DART SERVICE INSTRUCTION

TO AMEND INSTALLATION INSTRUCTIONS IIN-D350-600 REV. E AND INSTRUCTIONS FOR CONTINUED AIRWORTHINESS ICA-D350-600 REV. 5 OR LATER APPROVED REVISION

Α	NEW ISSUE; REF CAR 18-250		VS	18.11.30			
REV.		DESCRIPTION			DATE		
DESIGN	J [VS	DART AEROSPACE LT		<u>ו</u>		
DRAWN	1	VS	HAWKESBURY, ONTARIO, CANADA				
CHECKED RF		RF	DRAWING NO.		REV. A		
MFG. APPR. N/A		N/A	DSI 9814		SHEET 1 OF		
APPROVED DSW 』		DSW 🍶	TITLE SCA				
DE APP	R.	DS-	REPLACEMENT LOWER HINGE

FIGURE 1: LOWER HINGE ASSEMBLY (-541/-542 CHG 001) (-541 SHOWN, -542 SIMILAR)

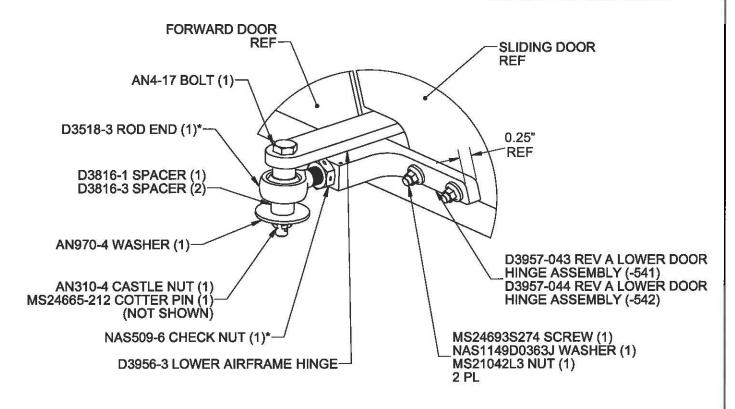
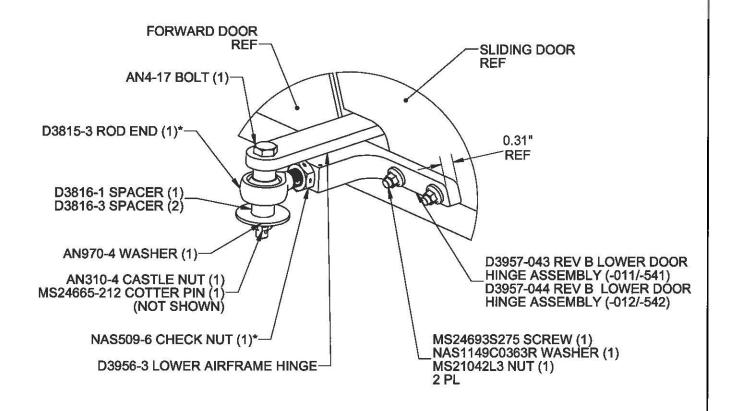
It has come to Dart's attention that the D3957-043/-044 Lower Door Hinge Assemblies that are part of the D350-600-541/-542 Sliding Door Hinge Kits at CHG 001 may fail prematurely in service. The purpose of this Service Instruction is to introduce the DSI 9814-011/-012 Replacement Hinge Kits with a stronger lower hinge design. The redesigned D3957-043/-044 Hinge Assemblies have a 0.31" thick base flange and are made of stainless steel (was 0.25" thick aluminum). D350-600-541/-542 Sliding Door Hinge Kits at CHG 002 and later include the improved lower hinge design.

- 2.1 Remove gas spring from the door.
- 2.2 Remove the AN4-17 Bolt, D3816-1/-3 Spacers, AN970-4 Washer and AN310-4 Castle Nut from the D3518-3 Rod End per Figure 1 and retain hardware. Take note of how many threads on the D3518-3 Rod End were protruding from the D3957-043/-044 Lower Door Hinge Assembly.

- 2.3 Remove the D3957-043/-044 Rev A Lower Door Hinge Assembly from the Sliding Door by removing the MS24693S274 Screws, NAS1149D0363J Washer and MS21042L3 Nut per Figure 1.

- 2.4 Install the new D3957-043/-044 Rev B Lower Door Hinge Assembly to the Sliding Door using the hardware shown in Figure 2.
 - NOTE: It is acceptable to install longer or shorter MS24693S2XX Screws to ensure 2-3 threads in safety

- 2.5 Adjust the D3518-3 Rod End to maintain the number of threads previously recorded in step 2.2. Install the Rod End onto the D3956-3 Lower Aircraft Hinge using the hardware from step 2.2 per Figure 2.

- 2.6 Open and close the door several times and verify no interference. Adjust door per ICA-D350-600 if required.
- 2.7 Tighten NAS509-6 Check Nut to 48-55 in-lb (5.4-6.2 N-m) after all adjustments have been made. Lockwire NAS509-6 Check Nut using MS20995C32 lockwire per AC 43.13 or MS33540.
